RE: Perry Nuclear Power Plant, Unit No. 1

The Commission has issued the enclosed Amendment No. 9 to Facility Operating License No. NPF-58 for the Perry Nuclear Power Plant, Unit No. 1. This amendment consists of changes to the Technical Specifications (TSs) in response to your application dated September 22, 1987.

Amendment No. 9
License No. NPF-58

FIGURE 6.2.1-1
CORPORATE ORGANIZATION

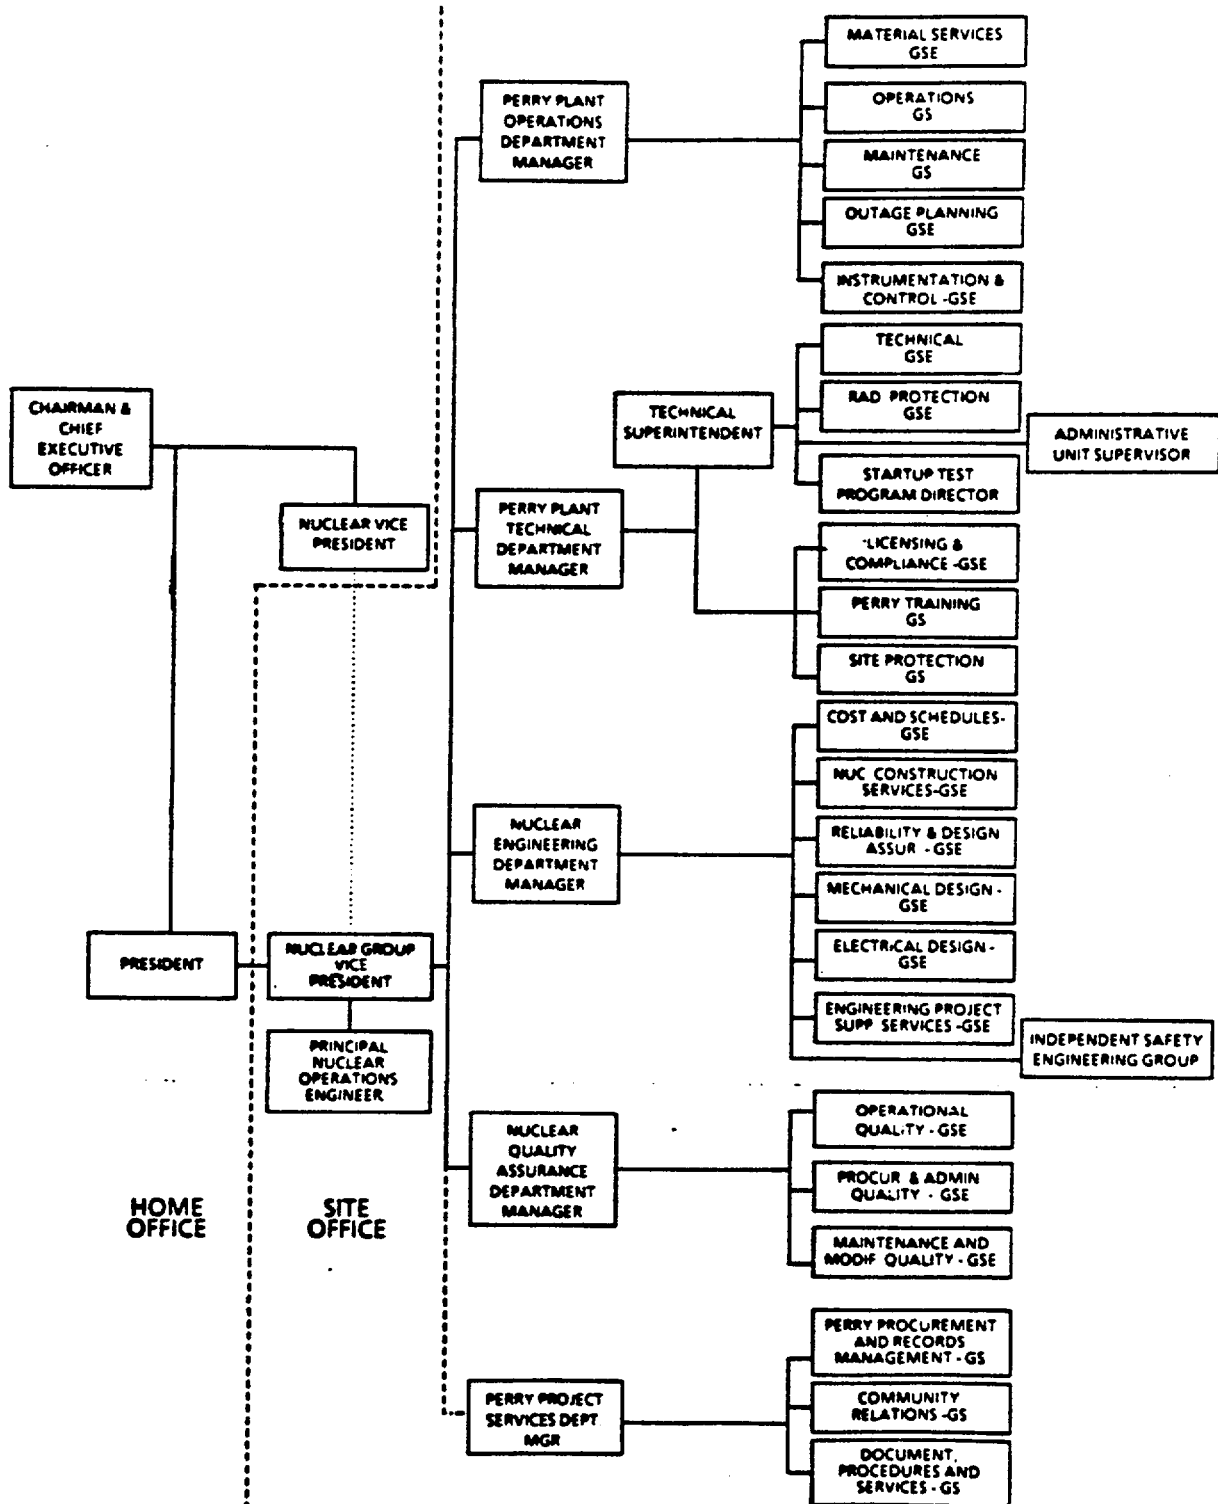
This amendment makes various changes to the organization charts, Figures 6.2.1-1 and 6.2.2-1 of the Technical Specifications, to revise titles and delete non-key positions.
